# STAFF REPORT

SUBJECT: H-2020-0104

Wadsworth Meridian Subdivision

Request for Preliminary Plat approval consisting of five (5) commercial building lots on 3.29 acres in the C-G zoning district for ownership purposes, by Wadsworth Development.

A. Preliminary Plat (dated: 09/28/2020)

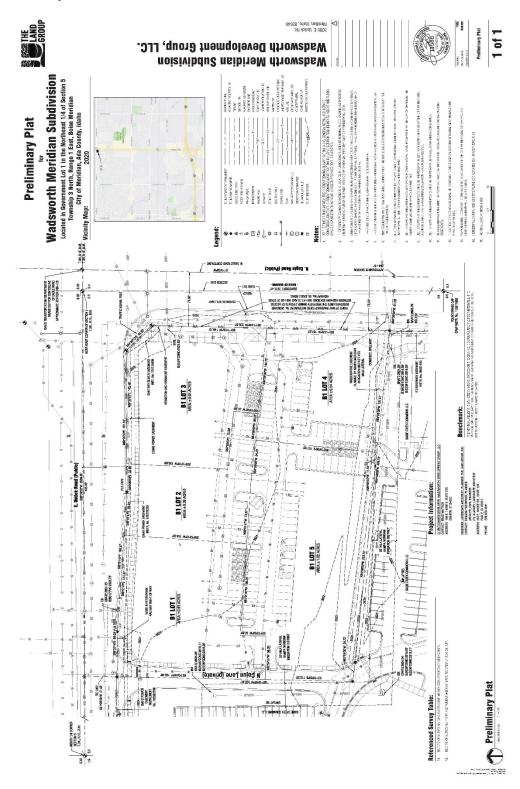
- 1. With the final plat submittal, the preliminary plat included in Section VII.A, dated September 28, 2020, shall be revised as follows:
  - a. Add a plat note prohibiting direct lot access to E. Ustick Road and N. Eagle Road.

- b. Add a plat note noting the existing cross-access agreement with the adjacent commercial properties (Parcel numbers S1105110110 & S1105110120) to include the recorded instrument number (Inst. #106169335).

- c. Revise plat note #11 to include the record instrument number for the Covenants, Conditions, and Restrictions (Inst. #2020-075457).
  - d. Remove the name of the shared driveway shown on the plat as N. Cajun Lane—this is not a named street in this location.

- e. Graphically depict the required landscape buffers along E. Ustick Road and N. Eagle Road on the plat per UDC 11-3B-7C.2.
- 2. The landscape plan included in Section VII.C, dated October 9, 2020, is approved as submitted.

# B. Updated Site Plan (date: 11/13/2020)

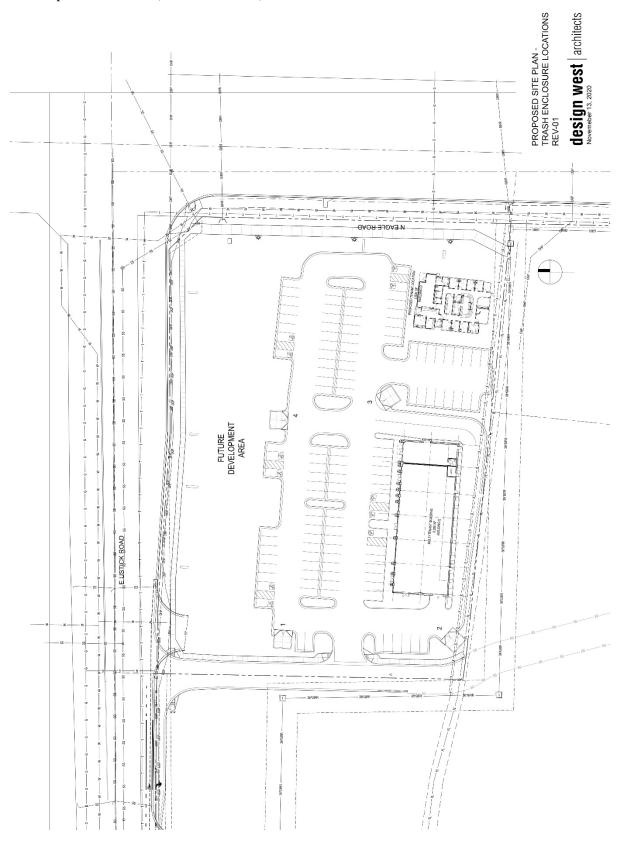
The revised site plan provided by the Applicant shows some changes to the parking lot that differ from the currently approved site plan. One of these changes include three additional trash enclosures for a total of four but none are proposed within the center parking area which is appreciated. The new locations of the trash enclosures should help minimize any blind corners when traversing the site. In addition, the Applicant is now showing reconfiguration of some of the parking spaces and additional parking adjacent to the northern building lots. These changes show a net positive gain of 16 additional parking spaces. Again, as each pad site is developed, the required number of spaces will be checked and the Applicant will be required to comply with code requirements. As noted above, parking for the whole site will be available for each building site per the recorded CC&Rs.

Because the overall parking plan has changed since the original approval of the CZC, the Applicant will need to obtain approval of a new CZC outlining the changes made to the site improvements prior to obtaining any more building permits.
